**30-043-20258 JICARILLA 15 #001**

**SOUTHLAND ROYALTY COMPANY LLC**

SRC requests approval to plug and abandon the Jicarilla 15 #1.  
Attached are the Proposed Procedure, WBDs, Reclamation Plan, and Noxious Weed Form.

Re: Permanent Abandonment  
Well: Jicarilla 15 1 API: 30-043-20258

## PROPOSED P&A

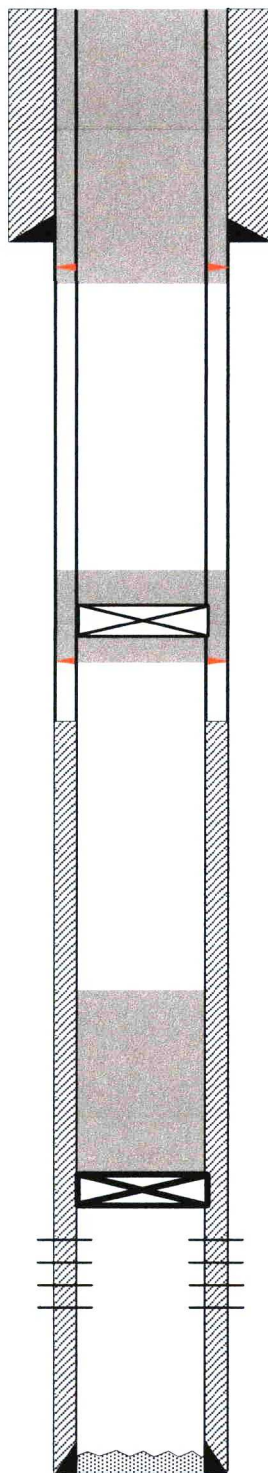
- Notify NMOCD 24hrs prior to beginning operations.
- Adjust plug #2 to 1317'-1217' to cover the Nacimiento top. BLM Nacimiento pick @ 1267'.

1. Plugging operations authorized are subject to the attached "General Requirements for Permanent Abandonment of Wells on Federal and Indian Lease."
2. Farmington Office is to be notified at least 24 hours before the plugging operations commence (505) 564-7750.
3. CBL required after setting CIBP from 2975' to surface to confirm TOC. Submit electronic copy of the log for verification to the following addresses: [jkillina@blm.gov](mailto:jkillina@blm.gov) and [Brandon.Powell@state.nm.us](mailto:Brandon.Powell@state.nm.us) . Based on CBL results inside/outside plugs and volumes may be adjusted accordingly.
4. BLM picks formation tops as indicated in the table below for use in determining TOC for all plugs.

<u>Top</u>
Nacimiento	1267
Ojo Alamo	2550
Kirtland	2705
Fruitland	2772
Pictured Cliffs	2933
